······	University Of Maine/Gra Build Parking Garage and person or person of the Statutes of maintenance and ks for street line of work requires	ange orthern, the moment ns, more of N ine ar	insperies in procu ding or the Original of the ildings and the original insperies in procu ding or the thereo provide the original	Permit Number ACA OMCO 115 B009001 Ding this permit shoes of the City of Petures, and of the ap A certificate o procured by ow	all comply with all ortland regulating plication on file in f occupancy must be wher before this build- eof is occupied.
Application And Notes, If Any, Attached This is to certify that has permission to AT	University Of Maine/Gra Build Parking Garage and person or person of the Statutes of maintenance and ks for street line of work requires	Burner, ange orthern, al-C composed of N ine ar d u of burner b ication g cand w b re this land or of	Inc.	Permit Number ACA OMCO 115 B009001 Ding this permit shoes of the City of Petures, and of the ap A certificate o procured by ow	all comply with all ortland regulating plication on file in f occupancy must be wher before this build-

Re: University of Southern Maine Parking Structure Walker Project No.

DT-100 CAST 6" TOO LONG.

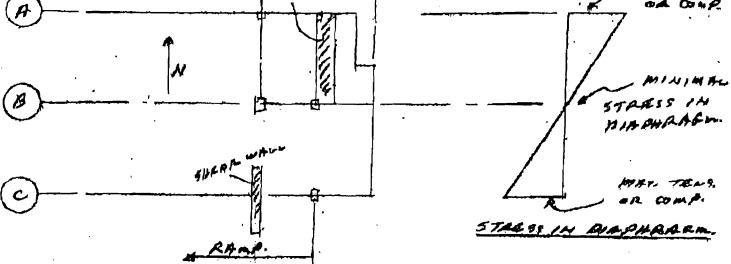
1. 6" TO BE CHT FROM SOUTH END. - (GRID B/9) 3. VECTOR CONNECTOR' FLANGE TO FLANGE CONNECTIONS FRENOT MEFFECTED. 3. RIAPHABON CHORD THE AT NORTH EDGE OF DIAPHABON CHORD THE AT NORTH EDGE OF DIAPHABON IS. NOT MEFECTED. 4. BT THE SOUTH END, (GRID B) THEAR IS LITTLE IF ANY FORCE ON THE CHORD THE CONNECTION. THE DIAPHABON IS A FLAT PLATE 3.BAYS CUIDE. FROM GRID A TOC. THE THES AT GRID B' MAR AT THE CENTER OF THE FLAT PLATE BEEN (SEE SLETCH). 8. 01-100 (1) MAX. TENT. BA DONE

THE THES WHEN BE OF PSET 6" (SEE PD 23A). THE BESHLT WILL BE & COMMENTION THAT DEVELOPS A AIMIMUM OF 1-15M COMMENTION THAT DEVELOPS A AIMIMUM OF 1-15M COMMENTION THAT DEVELOPS A 5. THE WELD BE IN THE D. TEE FOR COMMENT. 5. THE WELD BE IN THE D. TEE FOR COMMENT. TO THE BEAM (DETMIN PD 19) WILL BE CHT OFF. THIS WILL BE MERICAR BY PLUG WENDING A NEW SHO & TO THE 20M BARS AT THE TOP OK THE D.T. LEG. (SEE SHEET DY-RS)
